FirstEnergy Nuclear Operating Company

May 10, 2002
L-02-054

**Subject: Beaver Valley Power Station, Unit No. 1 and No. 2
BV-1 Docket No. 50-334, License No. DPR-66
BV-2 Docket No. 50-412, License No. NPF-73
Reply to Request for Information Concerning BVPS Responses to
NRC Bulletins 2001-01 and 2002-01**

BVPS Unit 2
Conoseal #1

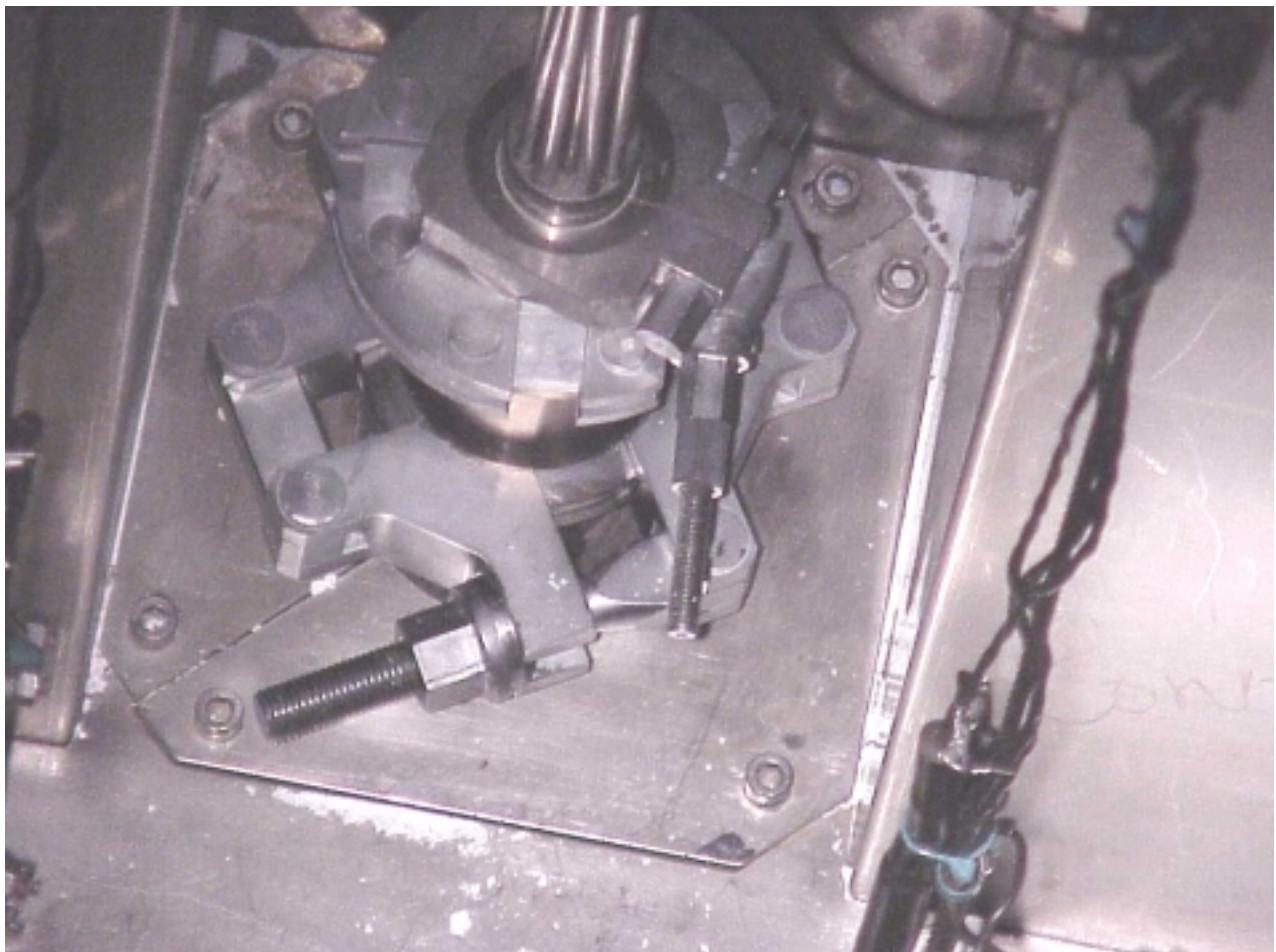
Were all known leaks repaired during the last Unit 1 and Unit 2 refueling outages so as to preclude the possibility of wetting of the deposits?

- At BVPS Unit 2, following the 2R09 refueling outage in February 2002, there was a light, dry dusting of boric acid observed on the upper surface of the #1 Conoseal when the system was initially pressurized to approximately 300 psi. Based on follow-up inspections of the area, it was determined that this was not an active leak. Additionally, during a subsequent forced outage on April 5, 2002, a containment entry was made and NDE personnel photographed the conoseal. The photos of the #1 Conoseal confirmed that there is no active leakage. (See Figure 3 which provides a copy of the subject photo.)

Photo taken during subsequent forced outage on April 5, 2002
(showing no evidence of active leakage)
